**MASTER DEVELOPMENT PLAN**  
TRIANA  
(FORMERLY KNOWN AS LOS REYES CROSSING)  
Bexar County, Texas

Re: **Triana Subdivision**

**MDP# 004-06**

The City Staff Development Review Committee has reviewed **Triana Subdivision** Master Development Plan **M.D.P.# 004-06**, please find enclosed a signed copy for your files. Your plan was accepted however please note the following:

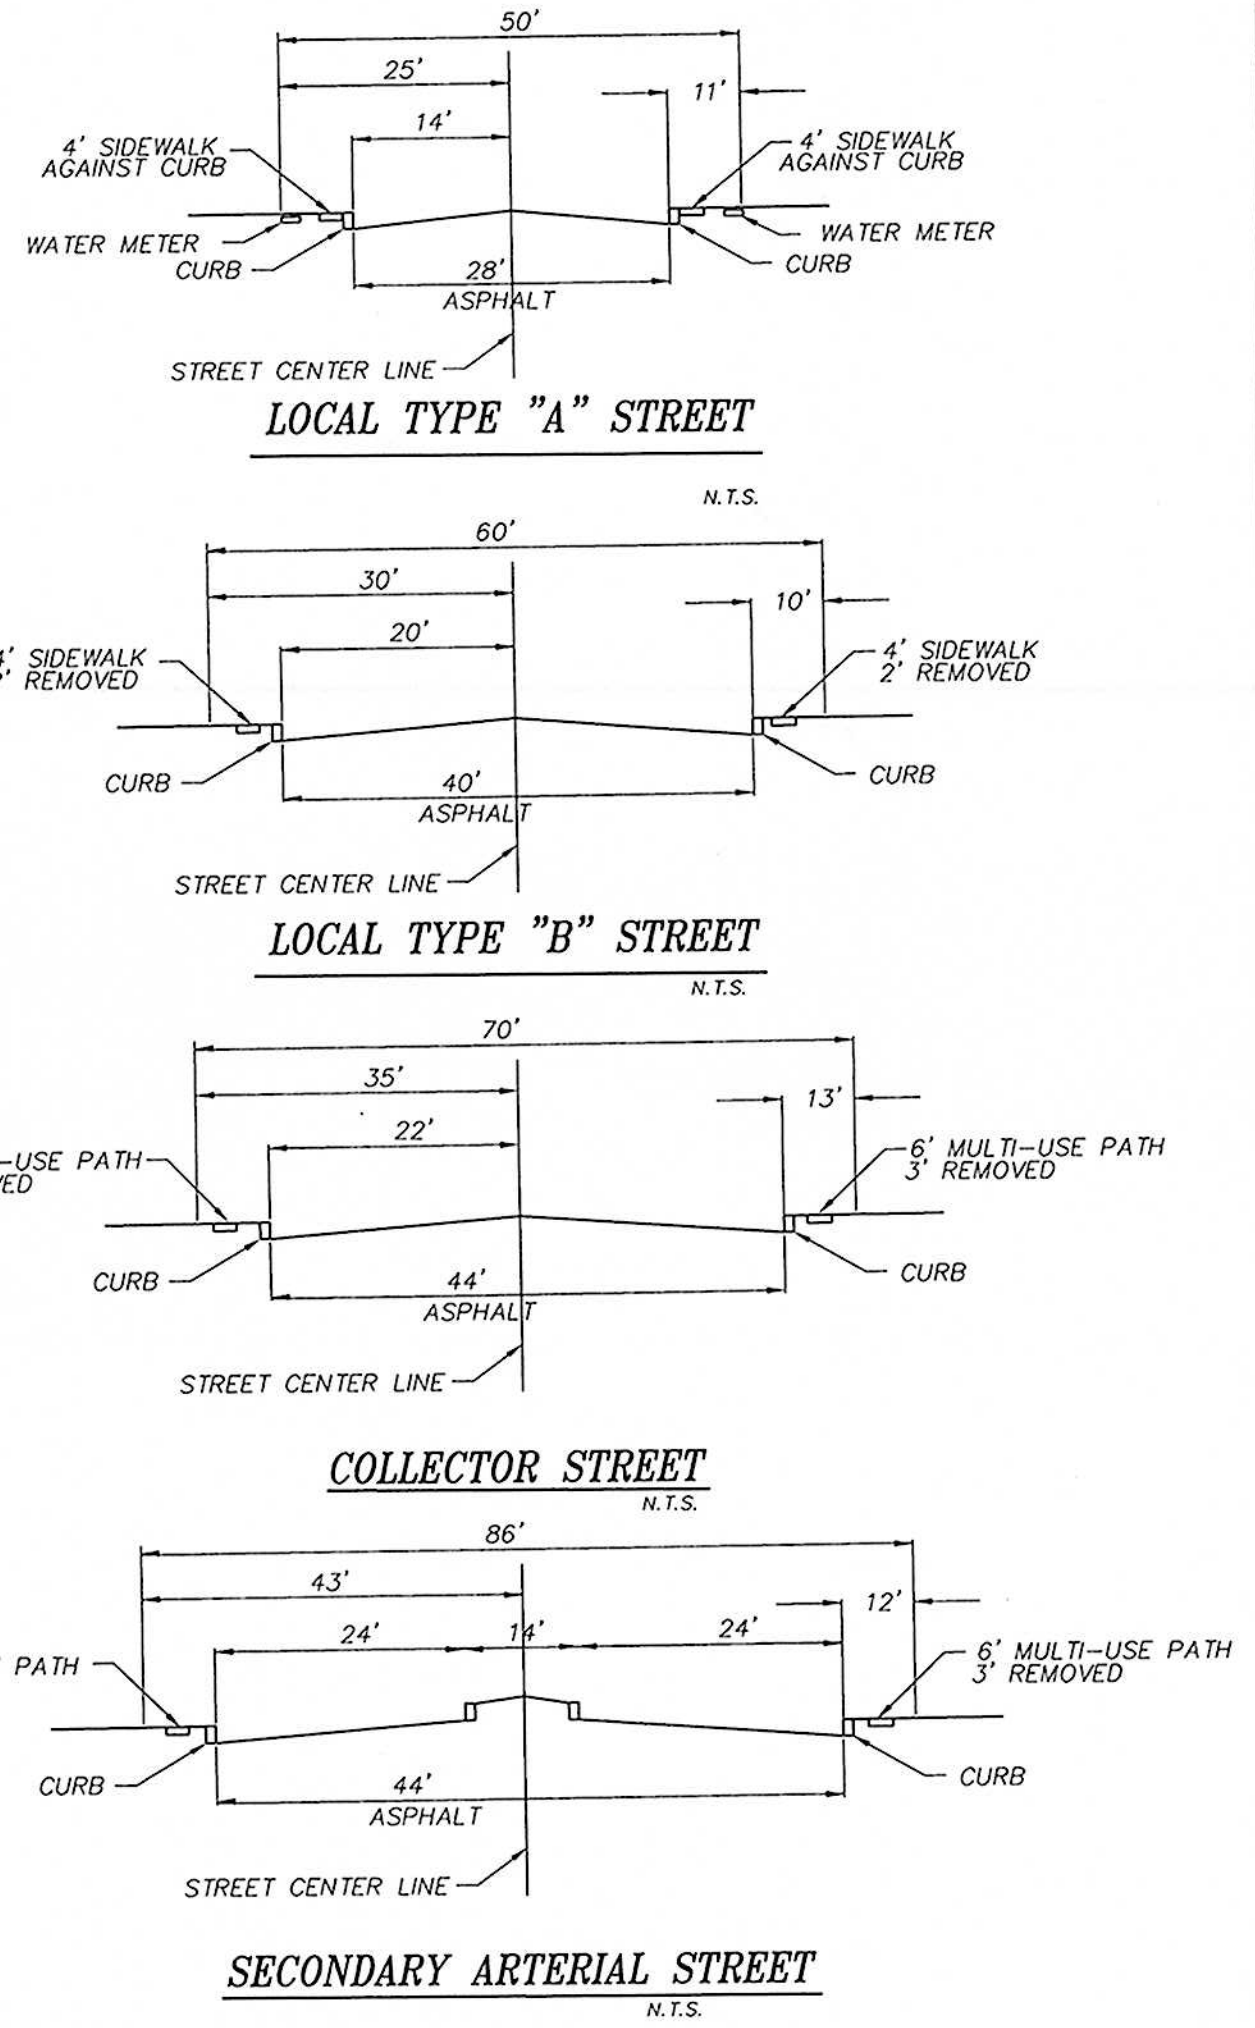
- In consideration of public safety and convenience, excessive grades by reason of topography should be avoided in street layouts and arrangements.
- Any access and R.O.W. issues along state facilities will need to be resolved with the **Texas Department of Transportation (TXDOT)**. For information about these requirements you can contact TXDOT at 615-5814.
- **SAWS Aquifer Protection and Evaluation** will require the following pursuant to the Aquifer Protection Ordinance No. 81491, for Plat Certification.
  1. 100 year Flood Plain Shown and Buffing (if applicable)
  2. Sensitive Recharge Features and Buffing (if applicable)
  3. Category Letter for All Site Specific Plats (if Category 2 or 3, an Aquifer Protection Plan is required)
  4. According to the Water Quality Ordinance # 81491, Section 34-914, buffering may be required.

Additionally, a Water Pollution Abatement Plan or Contributing Zone Plan must be submitted and approved with the Texas Commission on Environmental Quality (TCEQ) prior to construction.

**Historical Preservation:** The Texas Sites Atlas indicates that no archaeological sites have been previously identified within the above referenced property. A **historic agricultural complex with one standing stone structure** believed to date to the late 19<sup>th</sup>-century has been identified. Additionally, staff of the HPO believe there is a **high probability** that the property may contain

sites, some of which may be significant. Thus, before any work that might affect any sites is begun, we recommend that qualified professionals conduct an archaeological/architectural investigation of the property.

- **Bexar County Public Works** has indicated as part of their conditional approval, the following improvements will be provided by the developer prior to completion of the Triana Subdivision:

An administrative variance will be required from Bexar County at the time of planting strips between the curb and sidewalks of Local B, Collector and Arterial roadways.

All access to SH 16 adjacent to this site are recommended to be upgraded with exclusive right-turn lanes as per TxDOT standards.

Secondary access must be secured prior to the approval of any plat or combination of plats exceeding 125 dwelling units as per UDC 35-506(e)(7).

Traffic controls shall be warrants as per the Texas Manual on Unified Control Devices and Approved by TxDOT and / or Bexar County.

It is understood that this MDP is a conceptual plan and controlled access should be maintained in order to uphold safe and efficient traffic flow. Therefore, the developer of this property is encouraged to design common access and shared driveways between all proposed commercial lots. Bexar County reserves the right to address Driveways, Street Design, Sight Distance, ADA requirements, Drainage and Flood Plain issues at the time of platting.

- It will be expected that you will plat all of the property depicted in your Master Development Plan (M.D.P.), to include floodplains, drainage areas and open space.

- I would encourage you to work closely with the school district, so that they can plan accordingly.
